Reference: 24168-RGB-ZZ-XX-CO-ST-0003-SJ: DA 250804

**RE: STRUCTURAL DESIGN CHANGE – CAR PARK WALLS PUSHED OUT FROM PREVIOUS SSSA LAYOUT**

Figure 1: Original SSSA design – Short section

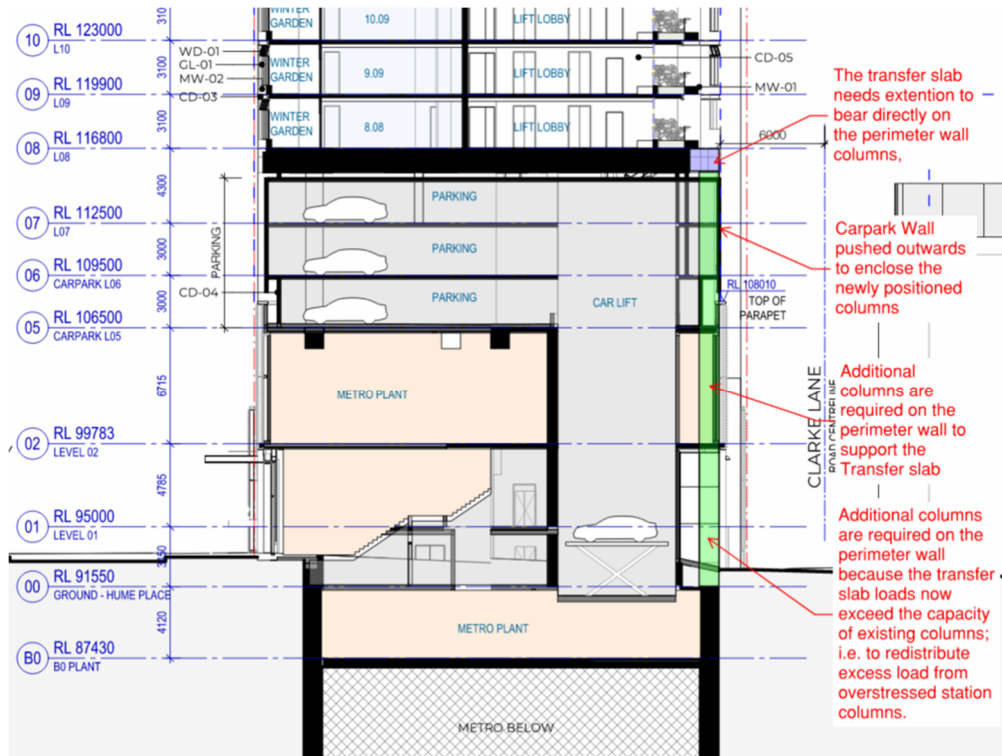
- Perimeter car park walls have been moved outward from the originally approved SSSA layout (Fig. 1 → Fig.2 and Fig.3 → Fig.4), in order to align with the newly added perimeter columns and transfer wall intended to support the Level 08 transfer structure.

- With the carpark wall relocation, new perimeter columns now directly support loads from the underside of the Level 08 transfer slab and beams.
- Without extending the columns on the perimeter wall vertically, there would be discontinuities in the load path, resulting in unsupported cantilevers and inefficient load transfer.
- Extending columns upward restores continuity, ensuring loads from Level 08 are effectively transmitted down through the structural system to the foundation.

Figure 3: Original SSDA Design – Hume St section

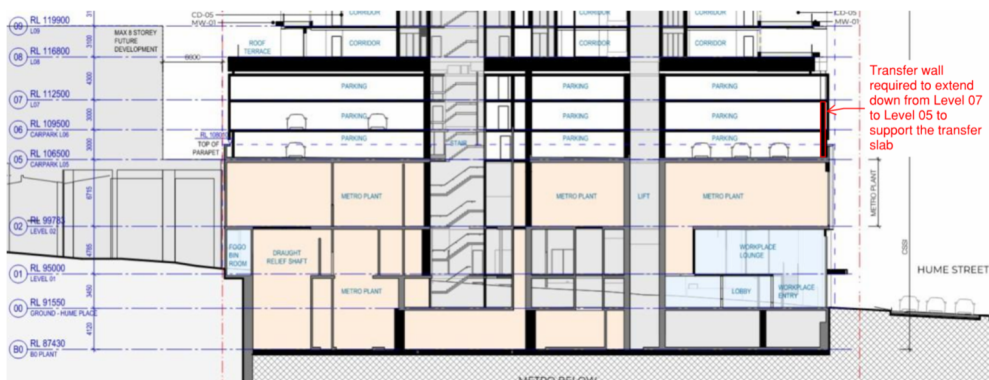
- A transfer wall has been provided along the Hume St side of the carpark to support loads from the Level 08 transfer slab and beams. The 400 thick transfer wall will extend down from Level 07 to Level 05.
- Similarly, without providing this transfer wall on Hume St, there would be discontinuities in the load path. Providing this transfer wall restores continuity, ensuring loads from Level 08 are effectively transmitted down through the structural system to the foundation.

- The originally proposed landscape buffer along the perimeter will need to be revised as it conflicts with the repositioned column layout and provision of the transfer wall.
- Keeping the landscaped zone as per the original SSDA would impede proper placement of structural columns and the transfer wall and could compromise the support of the transfer slab.
- Consequently, the landscaping zones must be reduced to maintain structural integrity and compliance with relevant building standards.
- The originally proposed landscape buffer along Hume St is no longer feasible due to the provision of the transfer wall in the same location.

Figure 5: Landscape Design Draft Level 05 Plan (RPS)

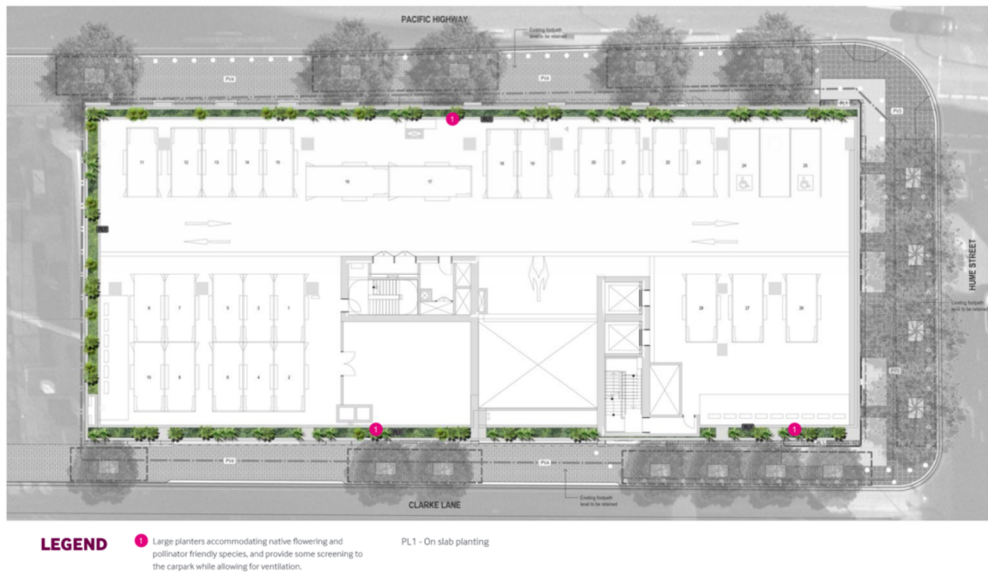
- With support from RPS, a portion of the landscaping areas can be reintroduced around the Level 05 carpark (not along Hume St) as per Figure 5 by allowing maintenance of the gardens through an access point from the carpark façade. A rope system may be required for the maintenance of the gardens along Pacific Highway. This is aimed to help compensate for the loss of landscaping zones due to the structural changes.
